SUBJECT: Nine Mile Point Nuclear Station
Unit No. 2; Docket No. 50-410

Response to Request for Additional Information Regarding Nine Mile Point Nuclear Station, Unit No. 2 – Re: License Amendment Request for Extended Power Uprate Operation (TAC No. ME1476)

RESPONSE TO REQUEST FOR ADDITIONAL INFORMATION REGARDING LICENSE AMENDMENT REQUEST FOR EXTENDED POWER UPRATE OPERATION (NON-PROPRIETARY)

Figure A5.1. Comparison of peak membrane (P_m) and membrane+bending ($P_m + P_b$) stresses at the hood/stiffener/base plate junction. These contours correspond to the nominal (zero) frequency shift.

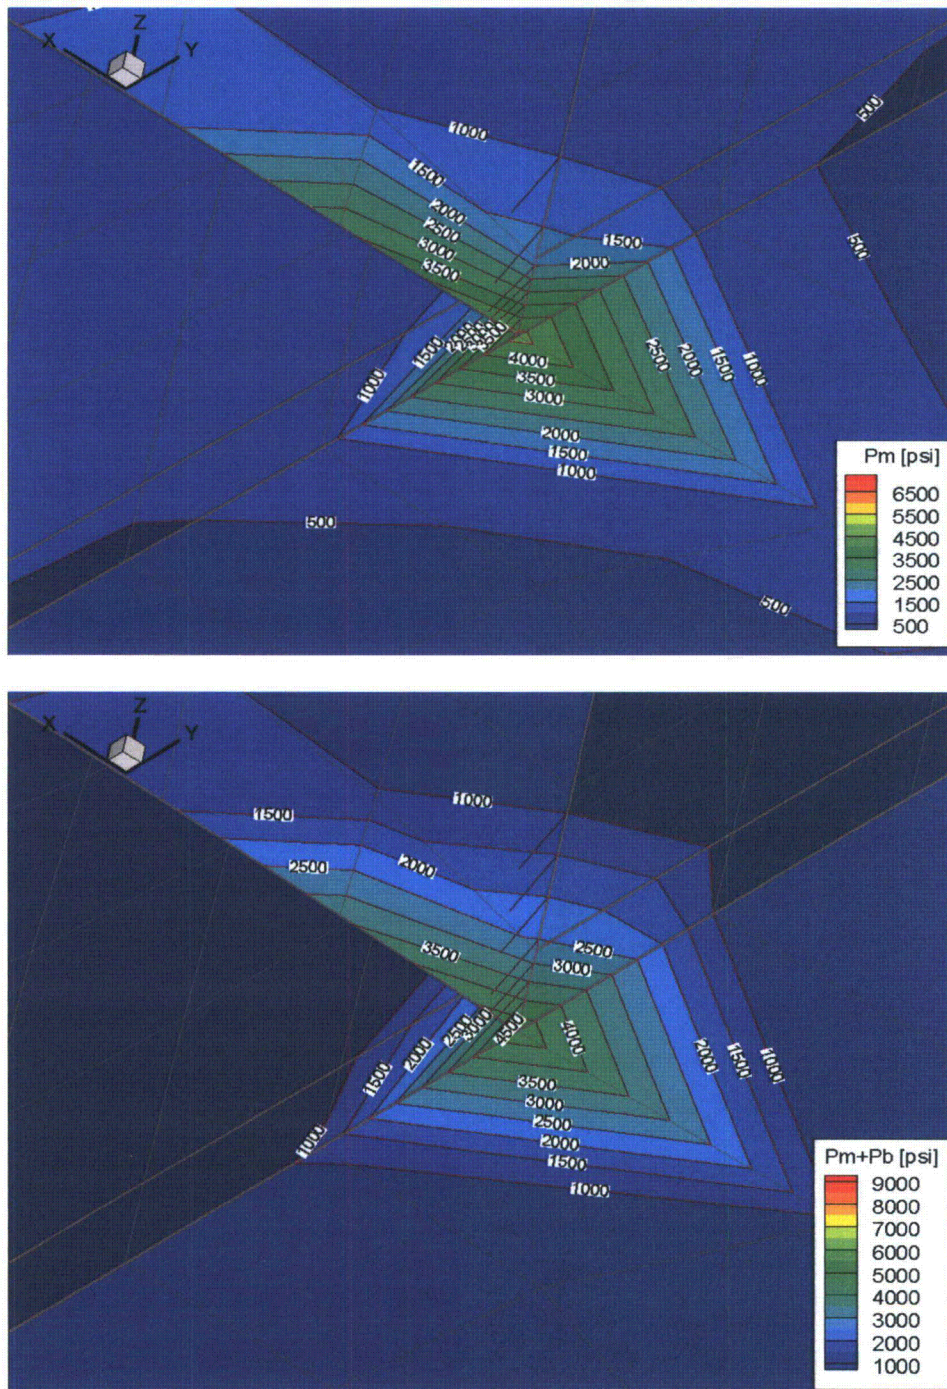
Appendix-A of CDI Report 09-26P describes the methodology used for submodeling the four locations with the stress reduction factors (SRFs) ranging from 0.62 to 0.88. Item 6 of Table 7 of CDI Report 09-26P lists an SRF of 0.79, but does not describe the submodeling methodology used for the location of the bottom of the hood/hood support weld at junctions of the base plate. The licensee is requested to address and clarify whether the submodeling methodology used for this location is the same as in Appendix-A, or discuss whether a non-standard submodeling approach was used. Also, the licensee is requested to provide a discussion of whether the forces and displacements at the cut boundary of the global shell model were imported to the solid submodel. The NRC staff does not endorse non-standard and unconventional submodeling approaches that use non-unique and arbitrary loading or displacements along with some arbitrary boundary conditions, to establish the applicable SRF value.

The stress distribution in the hood and base plate involves both membrane and bending components as can be inferred from Figure A5.1 and as would be expected intuitively given the dominant loading. Generally, the stresses in the base plate and hood near the junction act to resist the loads in the stiffener. Because of the hood/stiffener/base plate arrangement, other contributions to the local stress at the junction are expected to be small. To see this, note that stresses in the hood induced by hood vibration modes will be small locally because bending about the horizontal axis is constrained by the hood stiffener and bending about the vertical axis is prevented by the base plate. For the base plate, bending vibrations about the x-axis (i.e., the axis pointing from one MSL pair to the other) are prevented by the hood. Bending about the y-axis (pointing along the long length of the base plate) is not resisted, but the associated modal frequencies are expected to be high because of the relatively small width of the base plates. Finally, for the stiffener itself, it has already been established that the bending response is negligible. Since bending-induced stresses are either absent or suppressed near the junction, it follows
